Access Compliance Report

Public Rights-of-Way

Intersection ID: 47849	Main Street: SERAPE_RD	Cross Street: STONE_PORCH_RD	Location: SE
ADA ID: 0F37359AD6F6	Ramp Type: PerpDiag	Initial Pass/Fail: Fail	Overall Compliance: No
Severity Score: 12.5			
Codes/Mitigation Info/Possible Solution		Field Measurements/Component Compliance

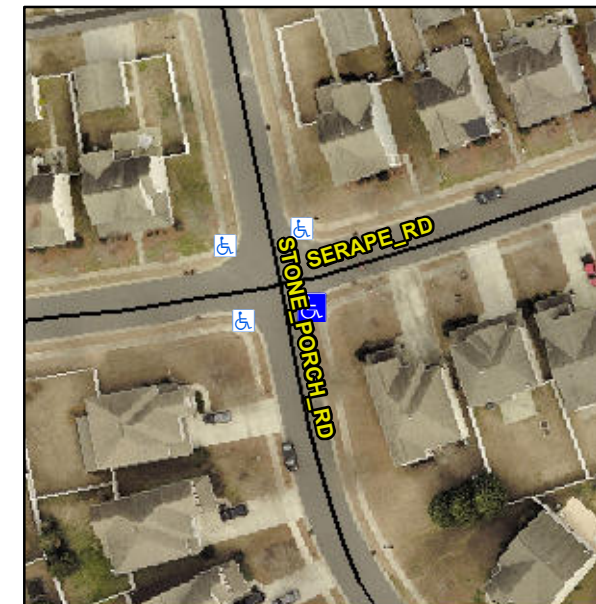
R304.5.3

Compliance	Description	Data	Compliance	Description	Data
N/A	Ramp Length (in)	52.0	Yes	Ramp Slope (%)	5.2
Yes	Ramp Width (in)	49.0	No	Ramp XSlope (%)	5.5
N/A	Flare Type LT	N/A	N/A	Flare Type RT	N/A
N/A	Flare Slope LT (%)	N/A	N/A	Flare Slope RT (%)	N/A
N/A	Flare Traversable LT?	N/A	N/A	Flare Traversable RT?	N/A
N/A	Landing Length (in)	N/A	N/A	DWS Provided?	N/A
N/A	Landing Width (in)	N/A	N/A	DWS Contrast?	N/A
N/A	Landing Slope (%)	N/A	N/A	DWS Length (in)	N/A
N/A	Landing X Slope (%)	N/A	N/A	DWS Full Width?	N/A
N/A	Landing Curb? (Y/N)	N/A	N/A	DWS Offset (in)	N/A
N/A	Shared Landing?	N/A			
N/A	Gutter Ponding?	N/A	N/A	Gutter Slope (%)	N/A
N/A	Gutter Lip Ht (in)	N/A	N/A	Gutter X Slope (%)	N/A
N/A	Painted X Walk1?	No	N/A	Painted X Walk2?	No
	X Walk 1 Direction	To N		X Walk 2 Direction	To W
N/A	X Walk 1 Width (in)	N/A	N/A	X Walk 2 Width (in)	N/A
	X Walk 1 Slope (%)	0.1		X Walk 2 Slope (%)	0.7
	X Walk 1 X Slope (%)	0.5		X Walk 2 X Slope (%)	0.5

Remove & Replace Curb Ramp With Two New Directional Ramps or Equivalent.
